Subject: Duke Energy Carolinas, LLC (Duke Energy)  
Oconee Nuclear Station, Unit 3  
Docket No. 50-287  
Unit 3 End of Cycle (EOC) 26 Refueling Outage  
Request for Additional Information (RAI) Response to  
3EOC26 Steam Generator Inspection

Duke Response to RAI's dated December 6, 2012

S/G A

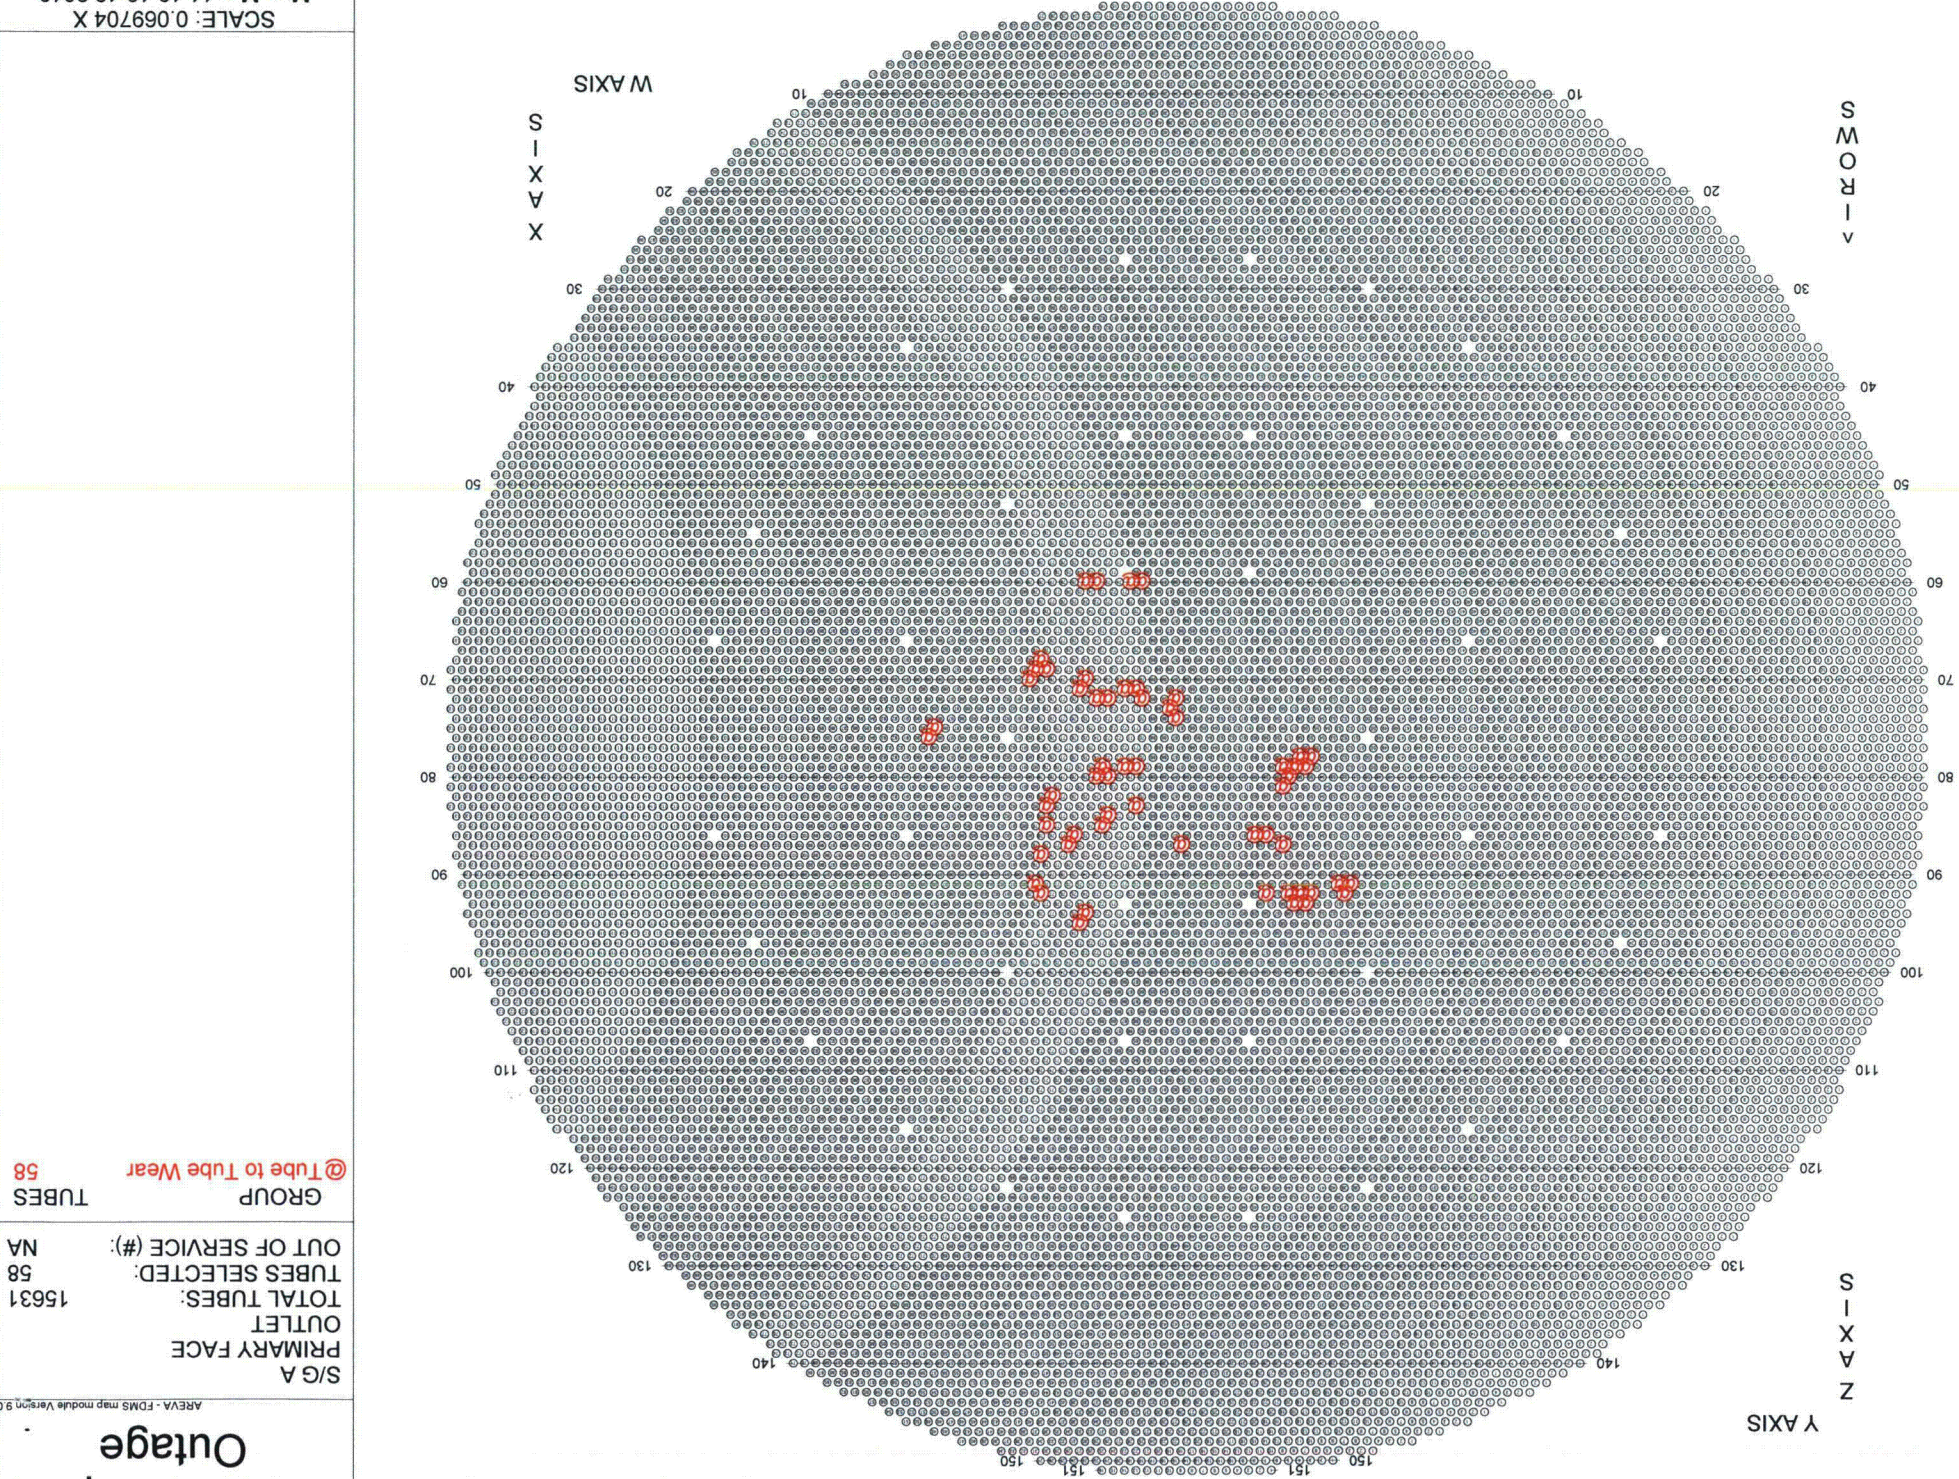
- c. Please provide tubesheet maps showing the locations of tube-to-tube wear for both Oconee Unit 3 SGs.

See attached.
